Re: Taxiway and Access Road Improvements  
Miller Municipal Airport  
Miller, South Dakota  
AIP #3-46-0035-016-2025  
Helms #A-8967

**ADDENDUM NUMBER 1**

**ADDENDUM NO. 1**

2. REPLACE the following plan sheets with the attached: E1, E4, E6, E7.
3. ADD the following new plan sheets which are attached: E106, and E107.

**40' TIP DOWN BEACON POLE  
(BID ALTERNATE 3)**

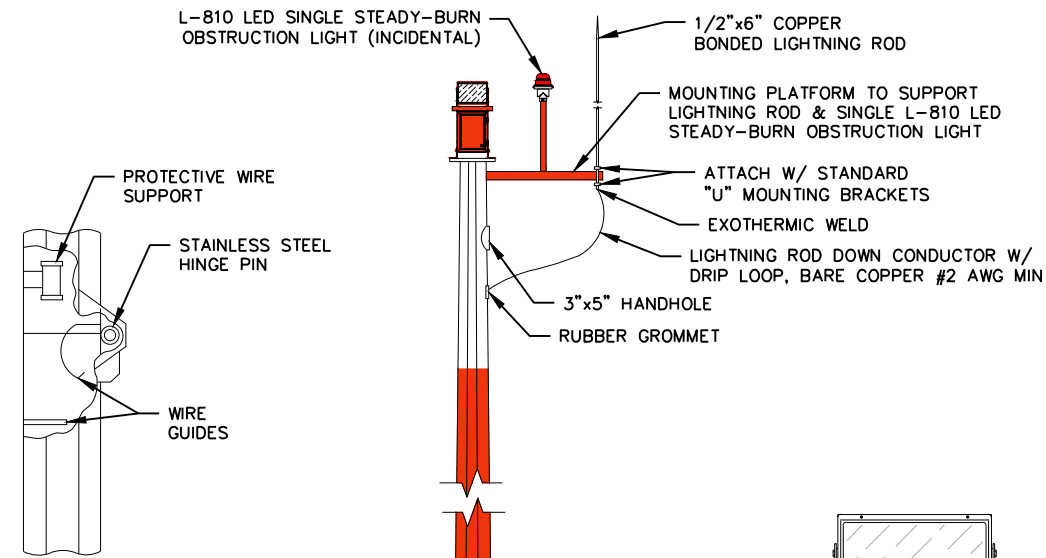
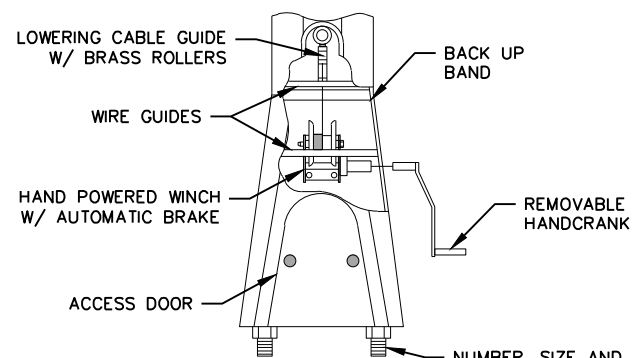
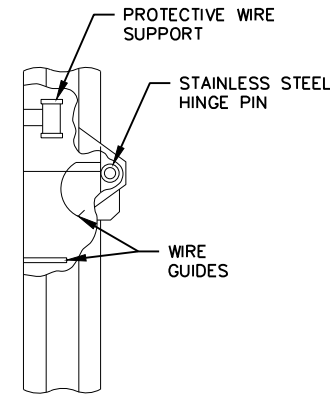
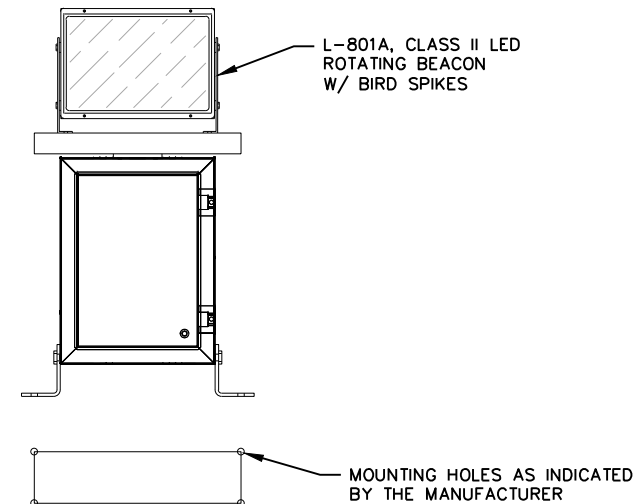
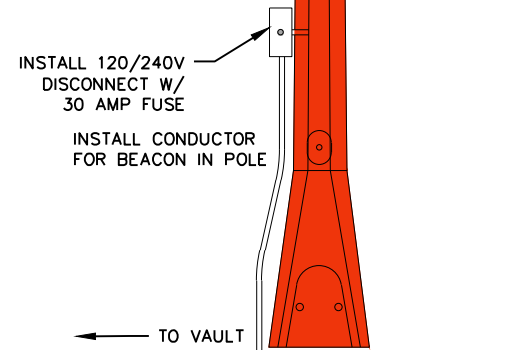
- EXISTING BEACON (REFER TO LIGHTING REMOVALS) (BID ALTERNATE 2 & 3)
- EXISTING BEACON JB (REFER TO LIGHTING REMOVALS) (BID ALTERNATE 2 & 3)
- EXISTING BEACON CONDUIT (TYP) (REFER TO LIGHTING REMOVALS) (BID ALTERNATE 2 & 3)
- EXISTING BEACON JB (REFER TO LIGHTING REMOVALS) (BID ALTERNATE 2 & 3)

**EXISTING TERMINAL BLDG (UAC)  
AND BEACON ON EXISTING  
WOODEN LIGHT POLE  
(BID ALTERNATE 2 & 3)**
